General Service Bulletin

HCOM-SB-73

Subject: Model E Compressor Crankcase Heater
(Trane Part No. HTR-0211)

Figure 1
Normal Voltage Hookup
for Crankcase Heater HTR-0211

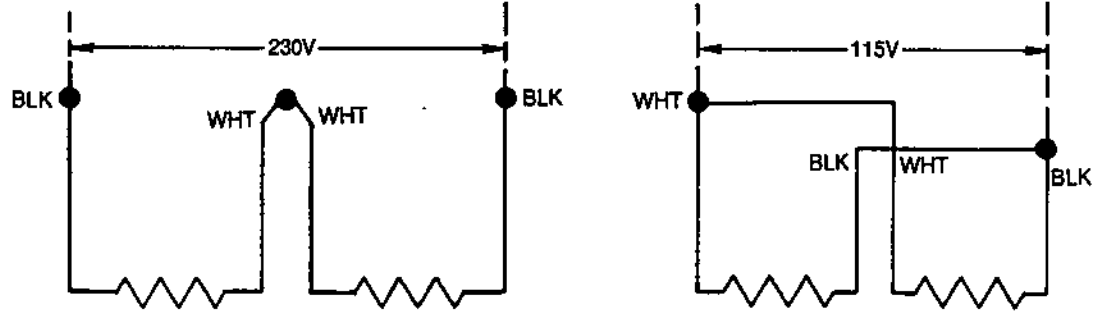
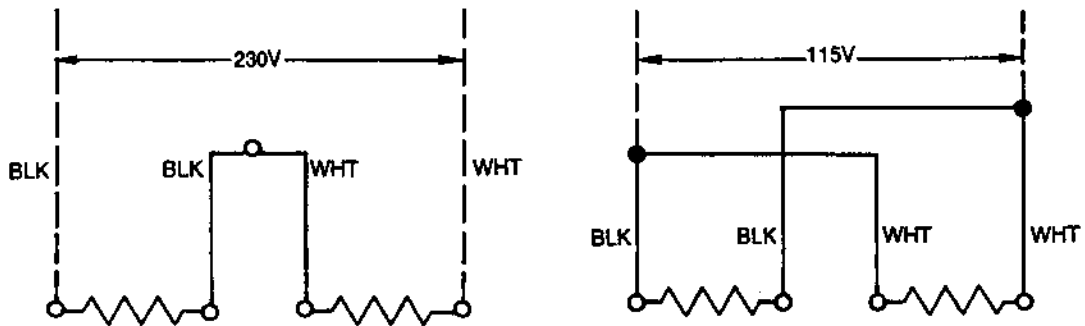
It was recently discovered that the wiring was changed in a vendor shipment of replacement crankcase heaters with June '87 package dates (Trane part no. HTR-0211 only). As a result of this wiring change, the crankcase heater will not function properly if it is wired in the normal manner, and not as shown on the wiring diagram that shipped with the heater.

If an HTR-0211 crankcase heater with "altered" wiring is not wired according to the vendor diagram supplied with the part, it will either be inoperative (115V applications) or burn up (230V applications). Compare the electrical diagrams in Figures 1 and 2 to distinguish the differences between the voltage hookups for a normal HTR-0211 and one with "altered" wiring. Figure 1 shows the field wiring connections normally used with HTR-0211, while Figure 2 illustrates the "new" field connections required as a result of the wiring change.

1. Return all replacement HTR-0211 crankcase heaters with a package date of "6/87" (June 1987) to La Crosse.
2. Reorder HTR-0211 to ship from La Crosse, Location 31. (The reordered heaters will be wired as normal; see Figure 1.)
